**Globemaster Corridor Specific Plan  
Program EIR/EIS (SCH No. 2018091021)  
EIR-03-17**

**City of Long Beach**

**DUDEK**

NOVEMBER 2020

**FIGURE 3.13-1**

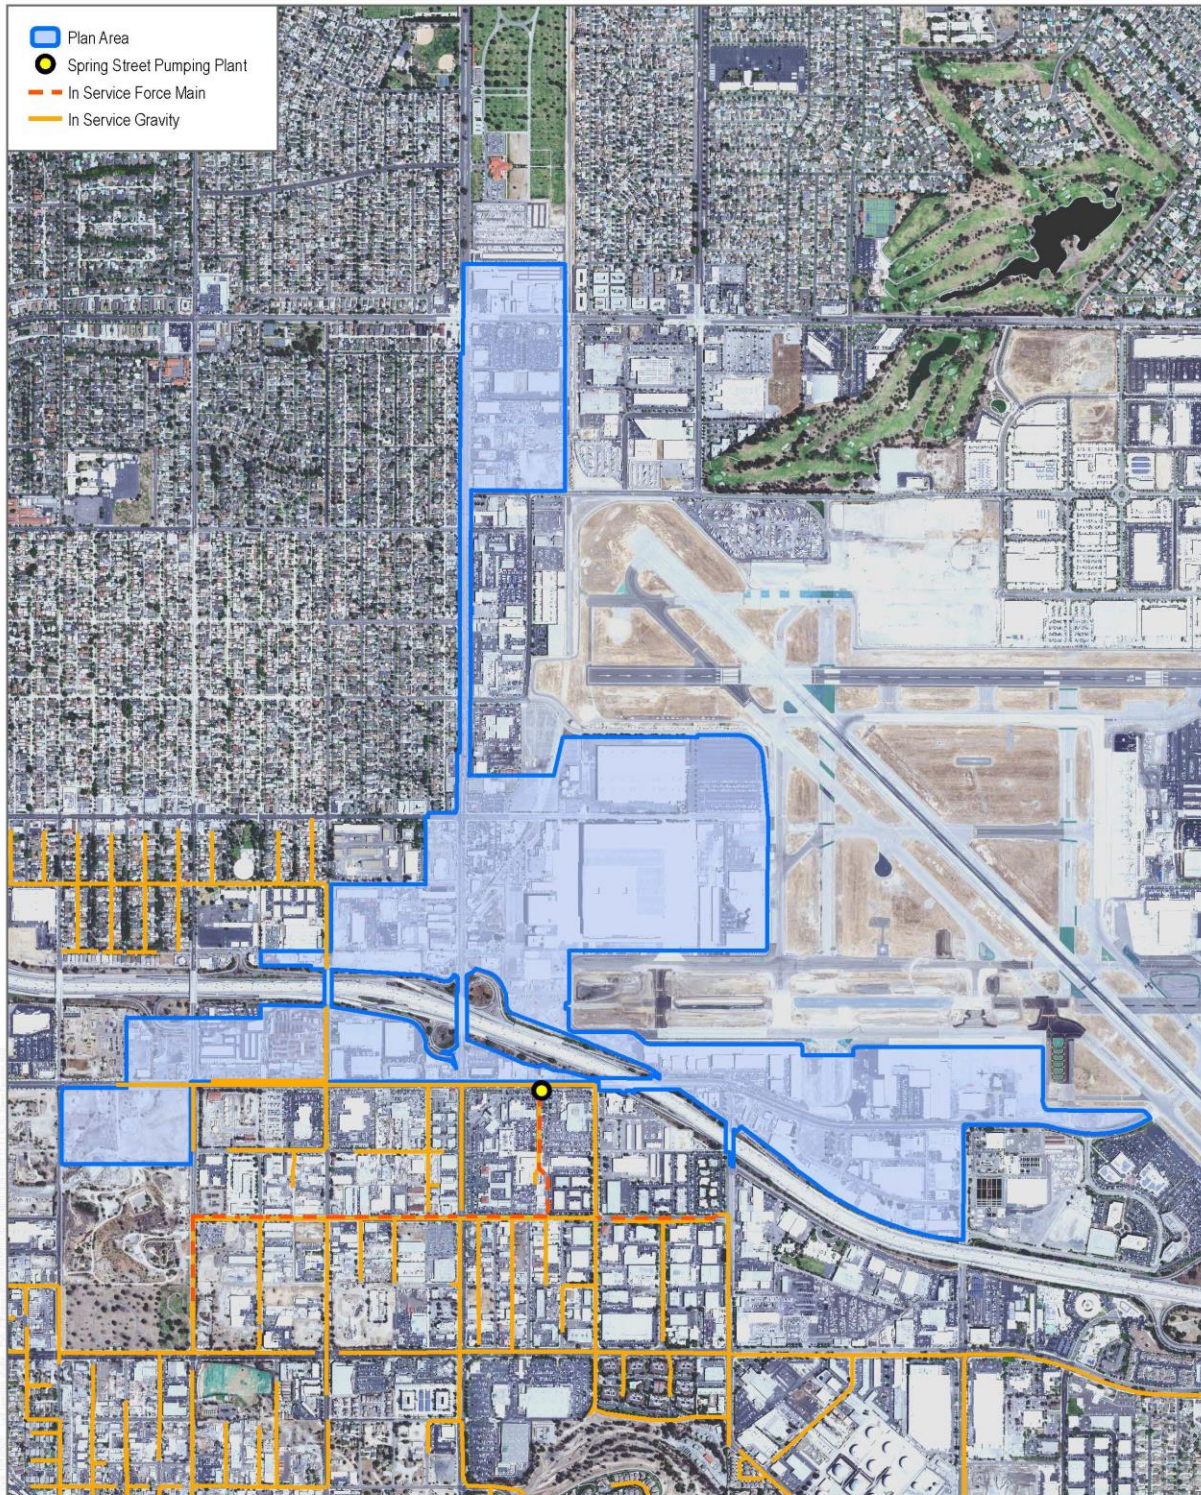
**7-4** The commenter raises issue with Section 3.13.1, Existing Conditions, in Section 3.13, Utilities and Service Systems, of the Draft PEIR/PEIS because it does not provide a detailed discussion on how wastewater is conveyed from the Plan Area to the LACSD trunk mains. As provided in Chapter 3, Changes to the Draft PEIR/PEIS, of this Final PEIR/PEIS, this section has been revised to include a more thorough discussion of LACSD's trunk lines within the Plan Area. In addition, a new figure (Figure 3.13-1, LACSD Sewer Lines) is provided in this Final PEIR/PEIS. Additionally, Chapter 3 of this Final PEIR/PEIS notes that sewer lines within the Plan Area would generally flow south toward Spring Street and then east toward the Spring Street Pumping Plant. Given the programmatic nature of the analysis, the existing conditions did not describe each existing lateral and local connections from within the Plan Area towards the LACSD facilities. Additionally, MM-UTIL-1 requires project-specific analysis that would describe the existing sewer facilities operated by LBWD and their flows towards LACSD trunk mains.

Figure 3.13-1, LACSD Sewer Facilities, has been added based on a comment provided from the Long Beach Water Department to include a more thorough discussion of LACSD's trunk lines within the Plan Area. See the revised figure attached to the end of this chapter of the Final PEIR/PEIS. The proposed revision does not alter the analysis or conclusions presented in the Draft PEIR/PEIS.
